**Technical Note
e-Notification**

No. 01
August 9, 2019

Technical Note 01

1. Stiffeners for Steel Multi-Girder Bridges:

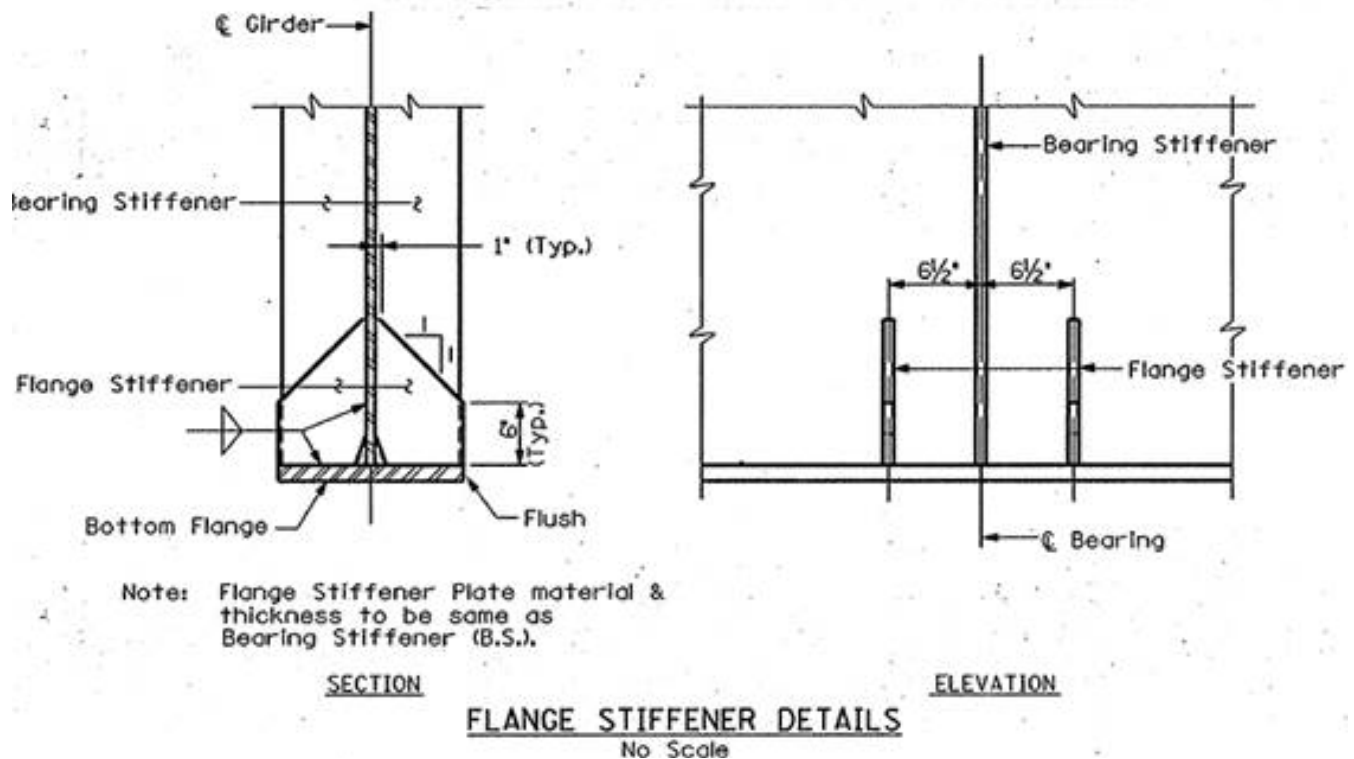
Input transverse stiffeners in BrR in the stiffener line item if they are full height and/or touch the compression flange. Flange stiffeners and connector plates that are partial height should not be input into BrR as stiffeners. If locations with flange stiffeners and partial connector plates control the rating and require posting, consider adding the stiffeners in BrR. Stiffener weights should be added in BrR per the Load Rating Guidance Document (LRGD).
